SUBJECT: Request for Additional Information - Copperwood Mine - Mining Permit Application Amendment Request March 2018 - MP 01 2012

The Michigan Department of Environmental Quality (MDEQ) has conducted an initial review of the Copperwood Mine Mining Permit Application Amendment Request (Application), March 2018, MP 01 2012. To assist in the completion of the review, please respond by addressing the following items of request for additional information to supplement, clarify, and support the proposed amendment:

Figure 1: Main Access Road Cross Section

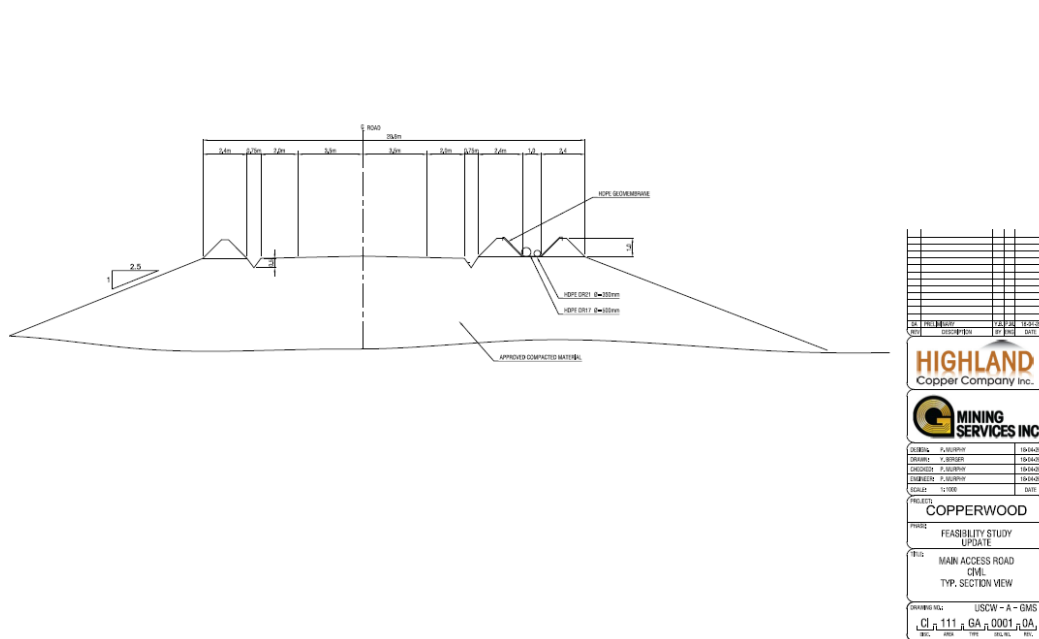
- 2. Explain how tailings will be transported to the Tailings Disposal Facility (TDS) in the proposed site layout, and include a figure showing the location of the tailings transport system.**

The transport of tailings slurry to the TDF and reclaim water from the TDF to the process plant uses pipelines which will follow the main access road. The cross section in Figure 1 below shows the designated space for pipes on the main access road.

Both the slurry and reclaim pipes will be HDPE pipes. The pipes will have a berm on either side of the pipelines with a geomembrane liner on the interior of the berms and underneath the pipelines. The system will naturally drain to the site event pond located next to the process plant.
